Before the Board of Inquiry  
Waterview Connection Project

Rebuttal evidence of **André Walter (Construction)** on behalf of the  
**NZ Transport Agency**

Dated: 3 February 2011

<b>VENT - SOUTH</b>	<b>DWG 002</b>
<b>PARTIAL UNDERGROUND OPTION</b>	Scale: 1:1000@A4

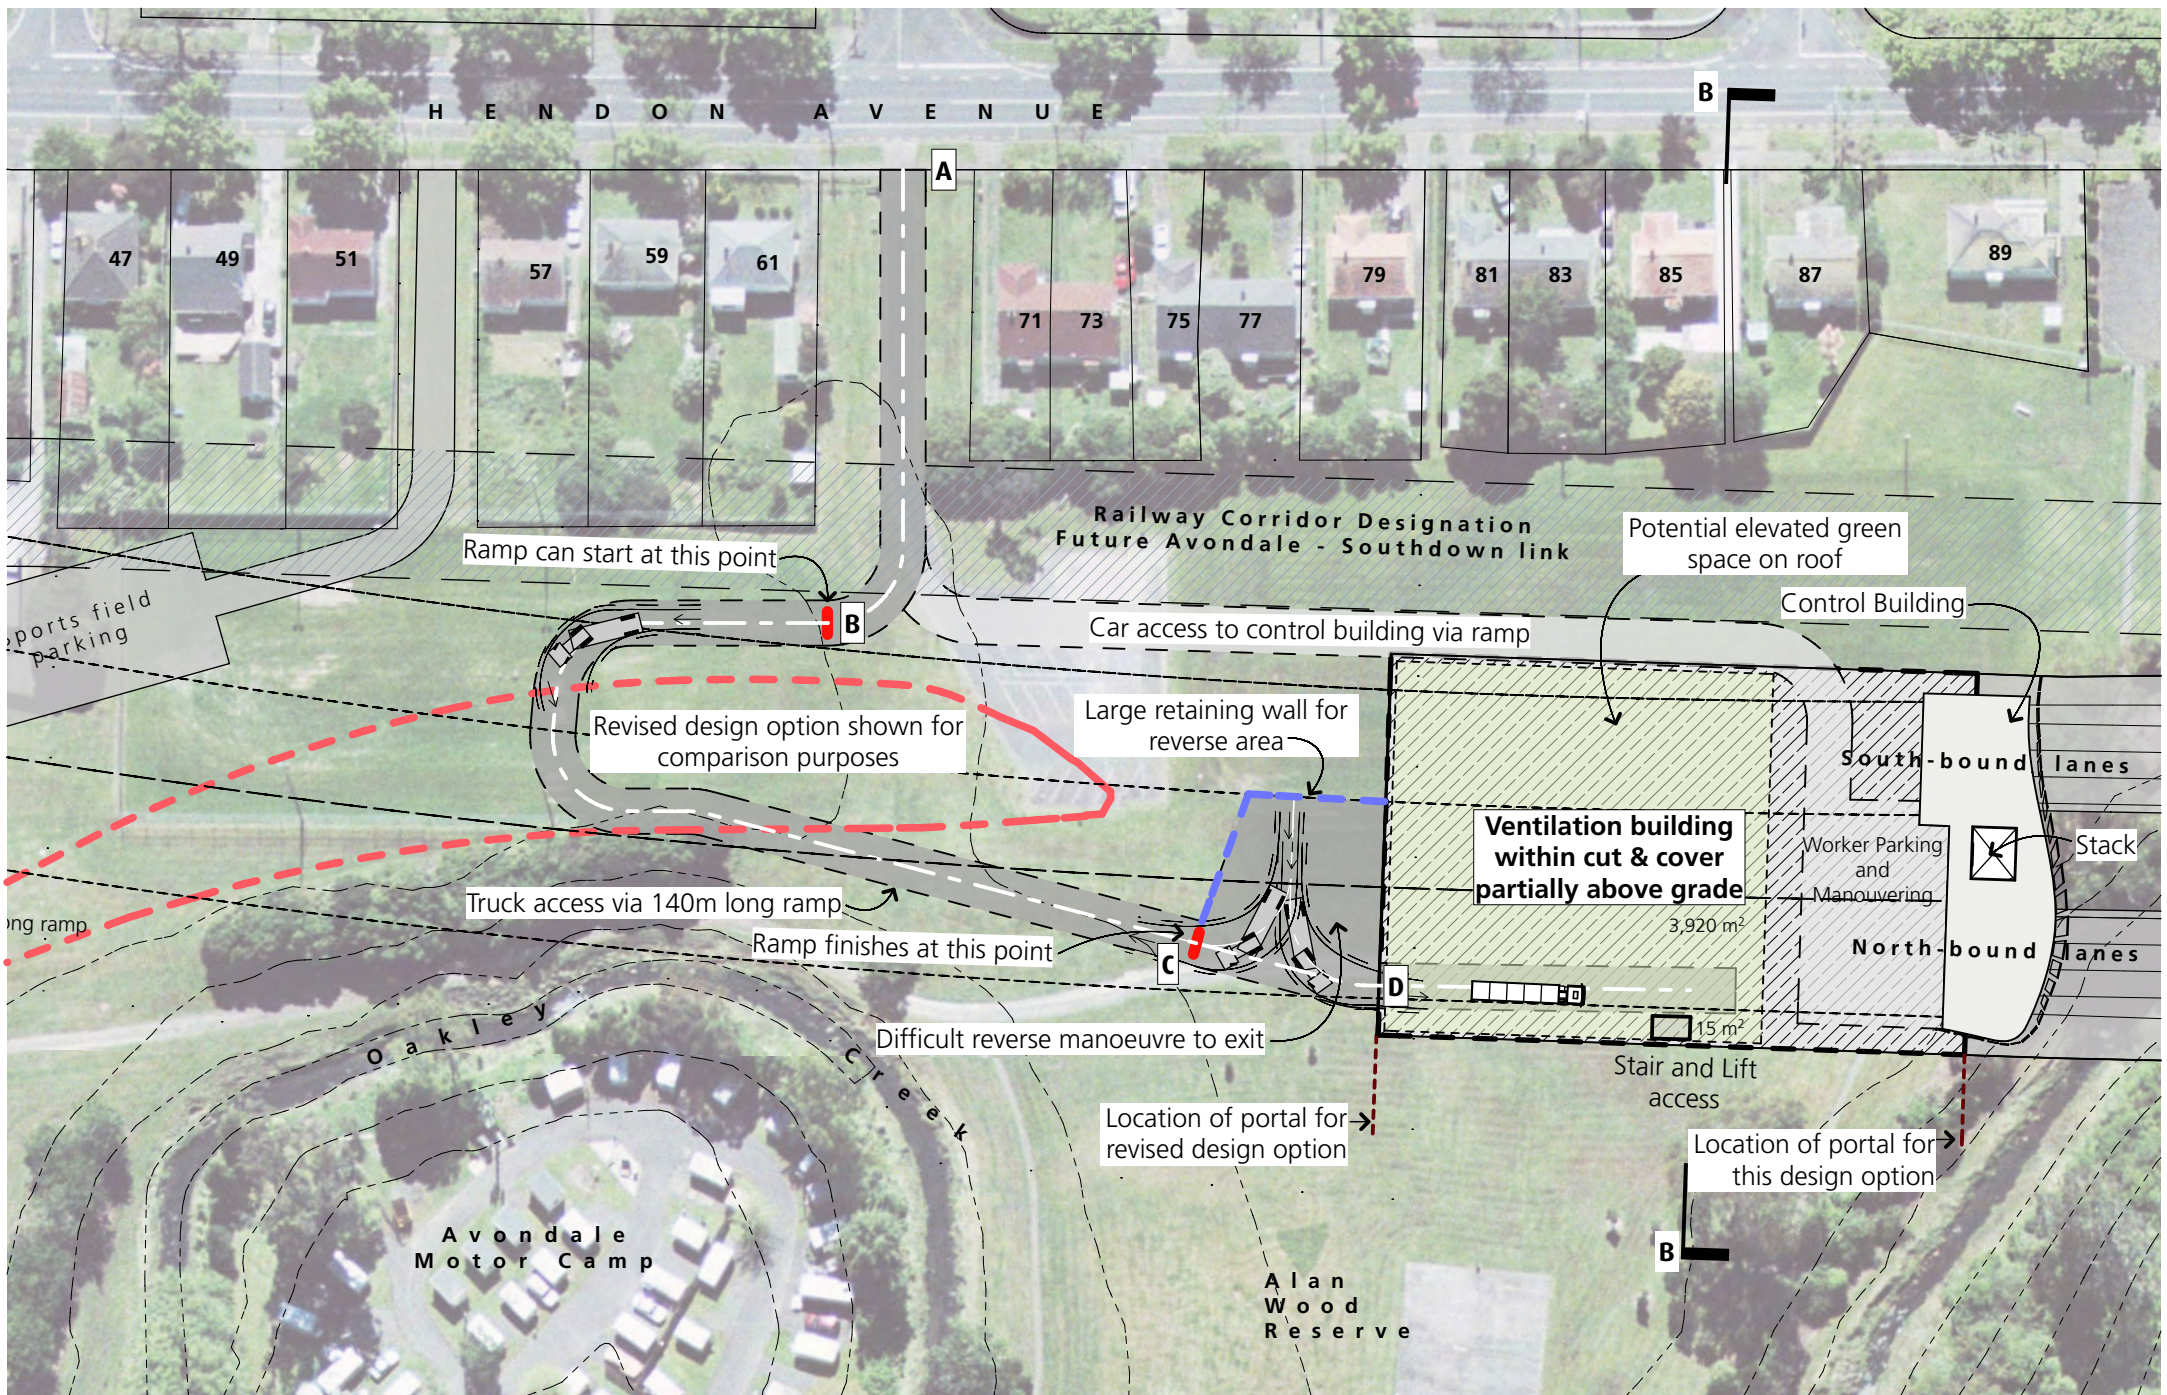
- 50 This option was considered to reduce the amount of open space that would be lost through road surfacing for the access ramp and roads, if the building was fully underground.
- 51 This option is shown within Drawings Vent South 002 and 002a providing a cross section and are included within **Annexure I**. It places the building partially within the deep cut prior to the driven tunnel portal. The building is elevated by 3m above the existing ground levels over its full extent.
- 52 Drawing Vent South 002 (**Annexure I**) shows that:
- 52.1 A ramp of 140m maximum length can be provided between points B and C, which is a reduction of 70m when compared to the fully underground ramp option. This would therefore

<b>VENT - SOUTH</b>	<b>DWG 002a</b>
<b>PARTIAL UNDERGROUND OPTION: SECTION BB</b>	Scale: 1:500@A4

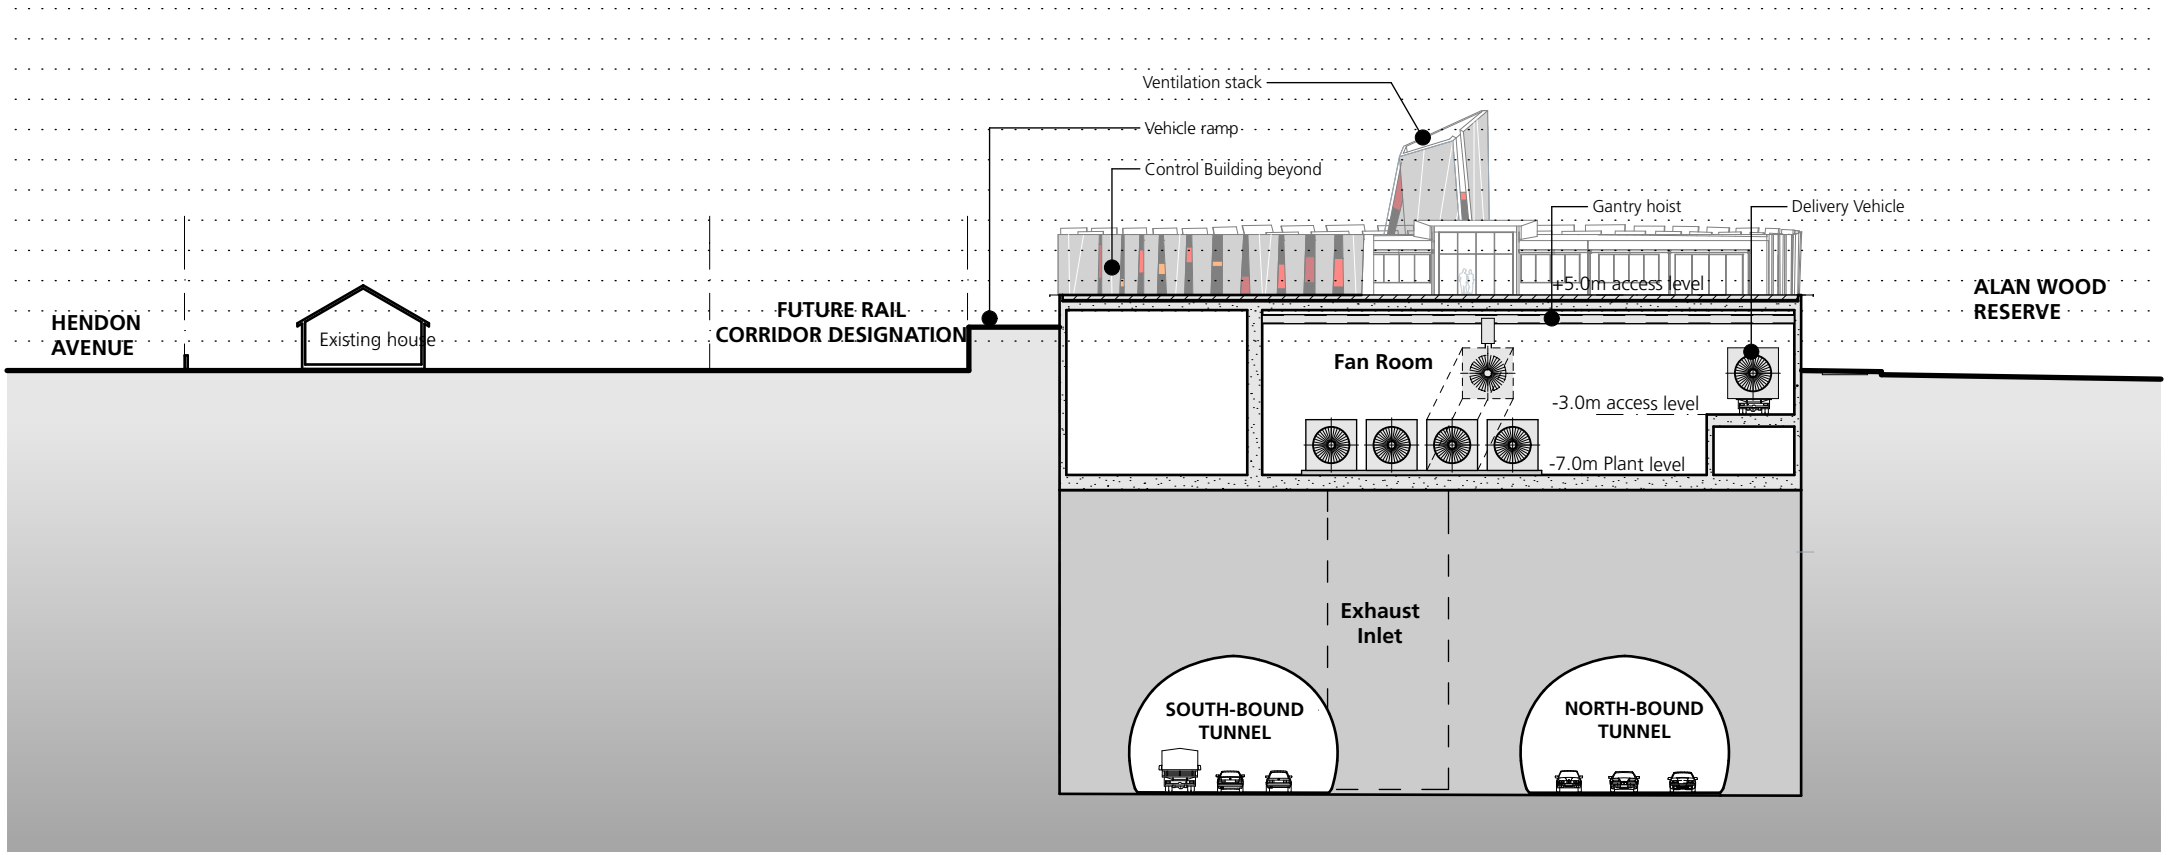
- 52.8 Removal and replacement of the ventilation fans and power equipment would be undertaken using a gantry crane arrange (shown in Drawing Vent South 002a).

<b>VENT - SOUTH</b>	<b>DWG 003</b>
<b>PARTIAL UNDERGROUND, SERVICED BY GANTRY OPTION</b>	Scale: 1:1000@A4

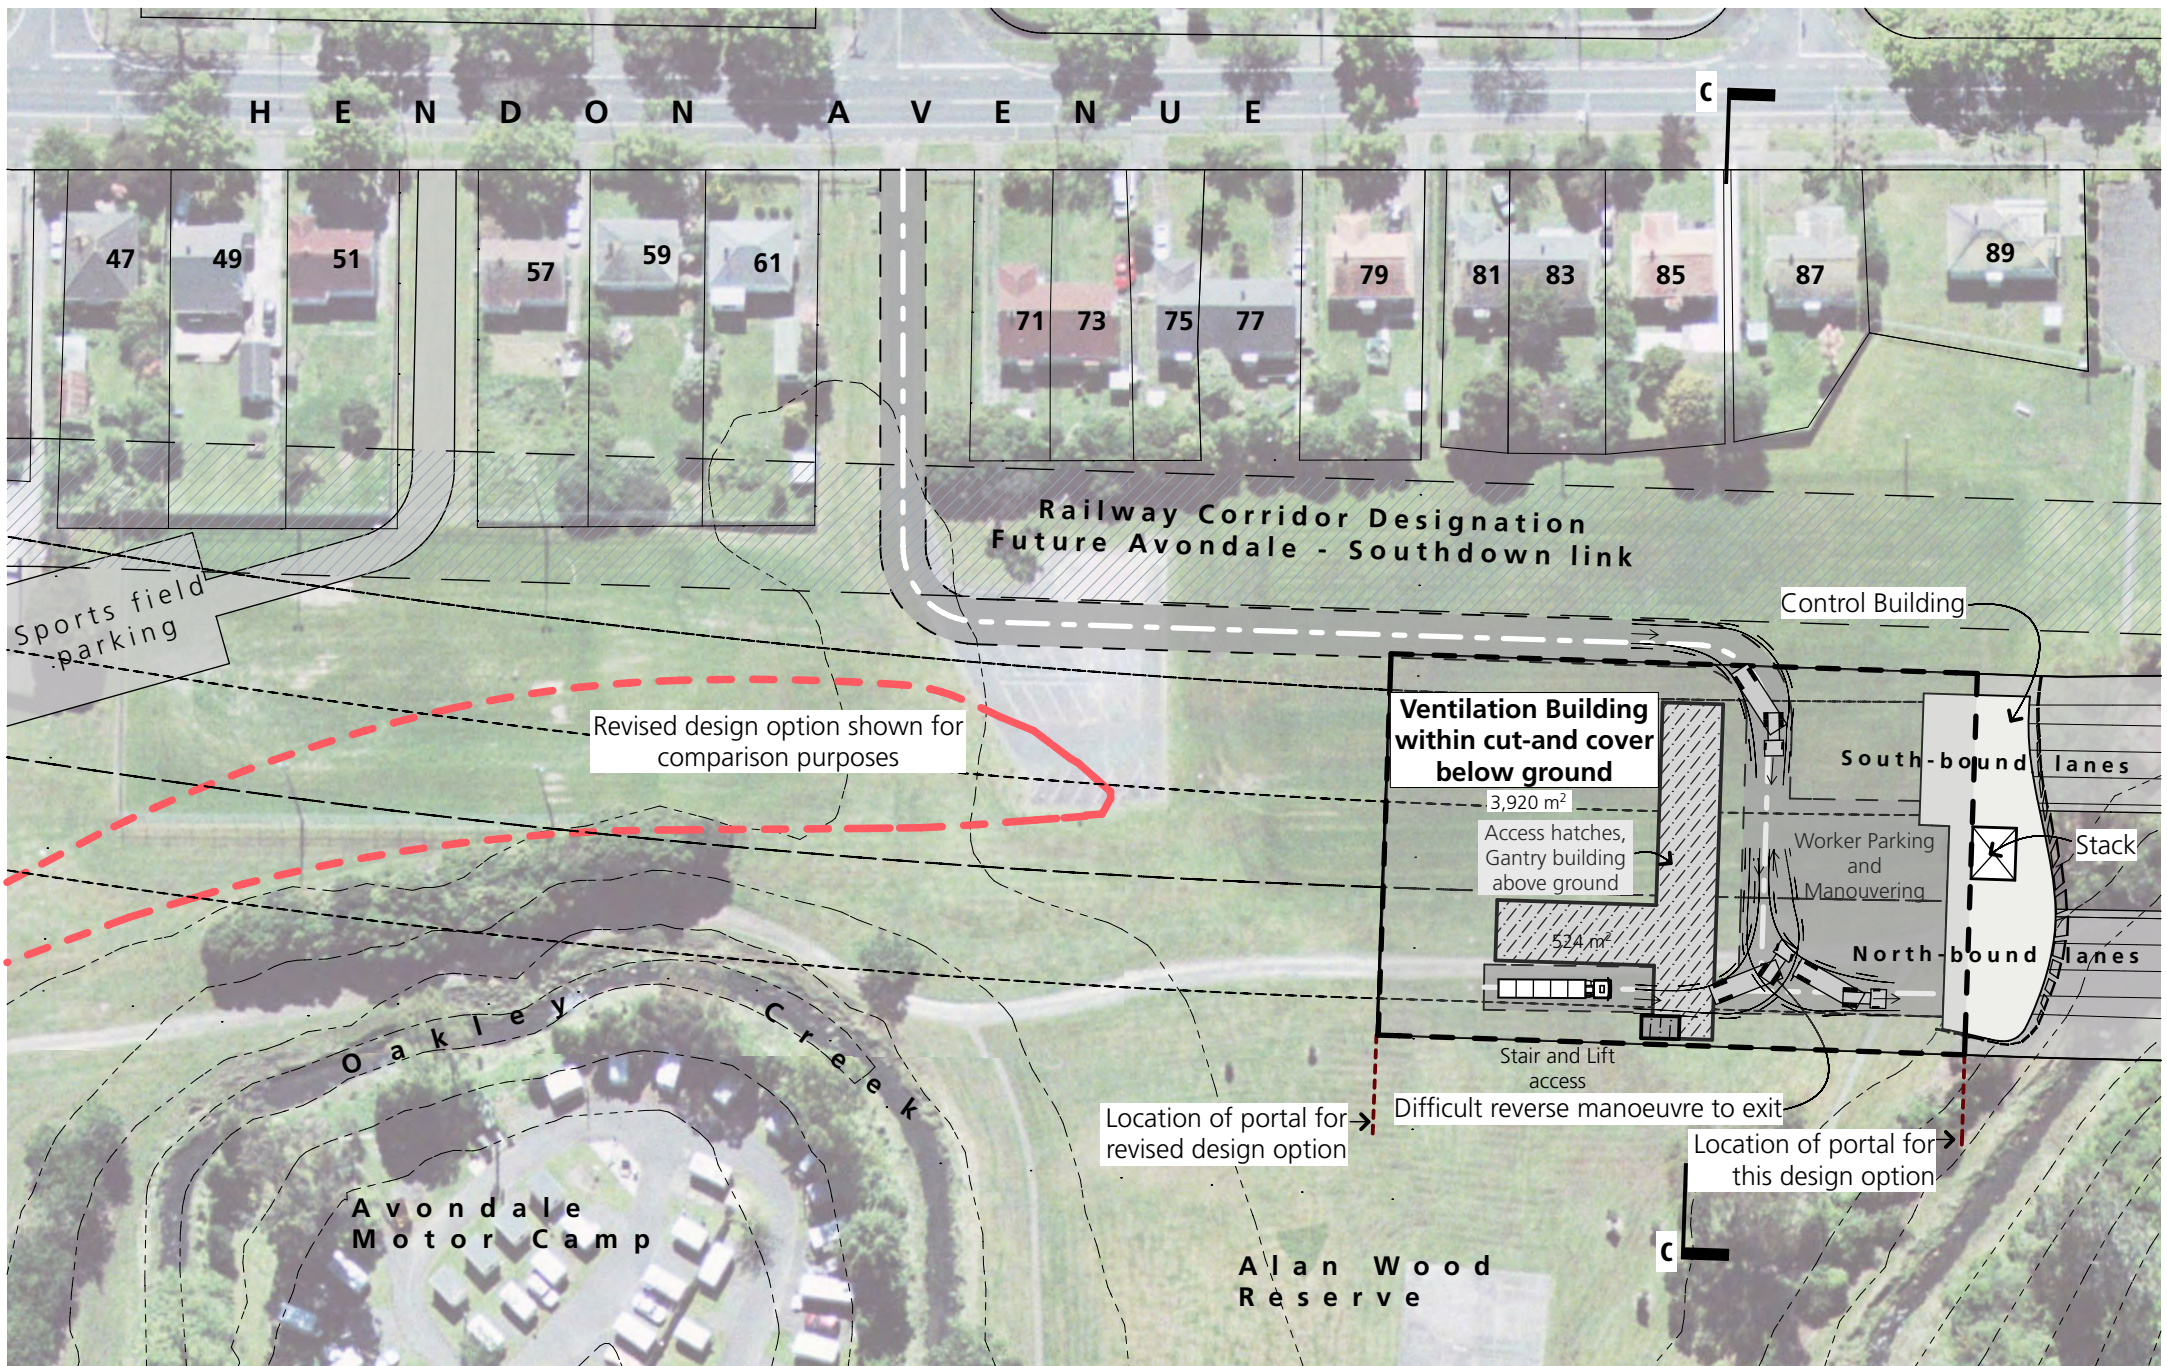
- 54 This option arising out of the caucusing process was considered to further reduce the amount of road surfacing that would be within the Alan Wood Reserve.
- 55 This option is shown within Drawings Vent South 003 and a cross section is shown on Drawing Vent South 003a attached as **Annexure J**. It places the building completely within the deep cut prior to the driven tunnel portal, with surface buildings provided to accommodate the gantry cranes for removal and replacement of the ventilation fans and power equipment.
- 56 Drawing Vent South 003 (**Annexure J**) shows that:
- 56.1 A ramp is no longer required and access to the gantry buildings can be provided off the access road to the operations centre.

<b>VENT - SOUTH</b>	<b>DWG 003a</b>
<b>PARTIAL UNDERGROUND, SERVICED BY GANTRY OPTION: SECTION CC</b>	Scale: 1:500@A4

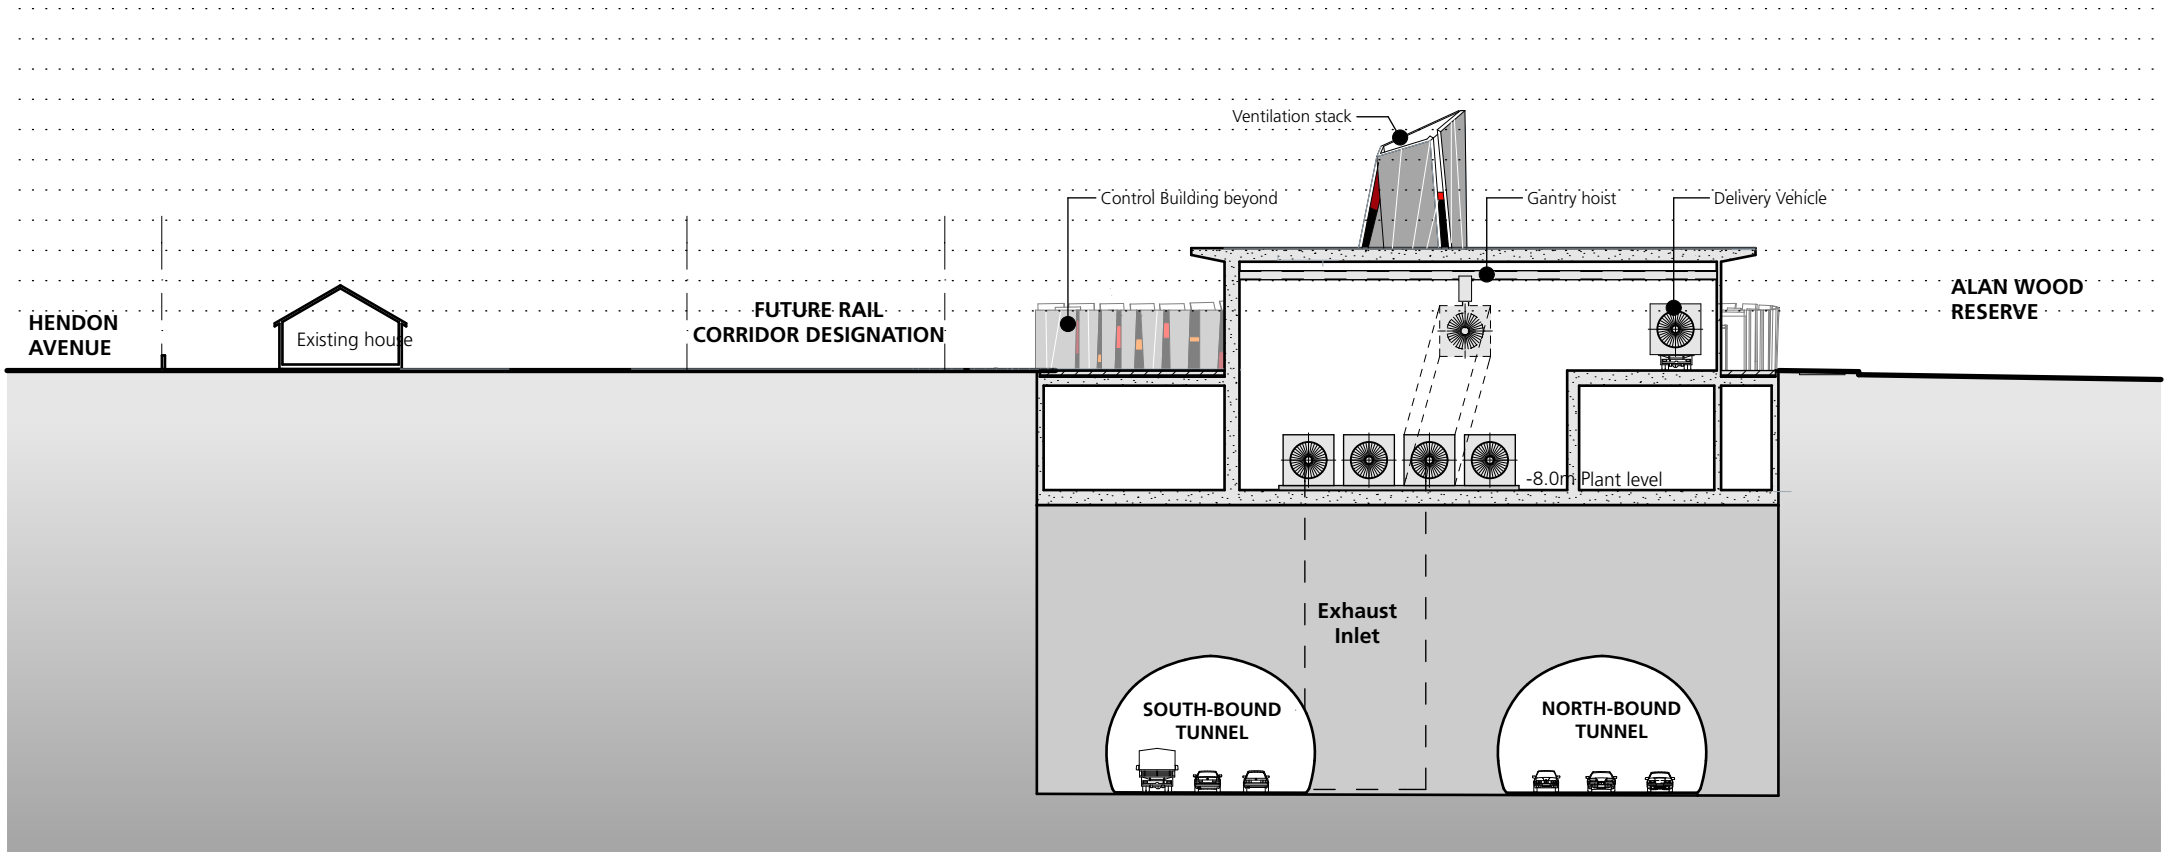
- 56.3 The operations centre would remain as a surface building.
- 56.4 Removal and replacement of the ventilation fans and power equipment would be undertaken using a gantry crane arrange (shown in Drawing Vent South 003a).

- 56.5 The gantry cranes would be housed with an L-shaped building with a floor area of 524m<sup>2</sup> and it would be 8m high. Within this building, the stair access and an industrial lift to remove and replace that equipment which cannot be done with the gantry cranes would be provided.
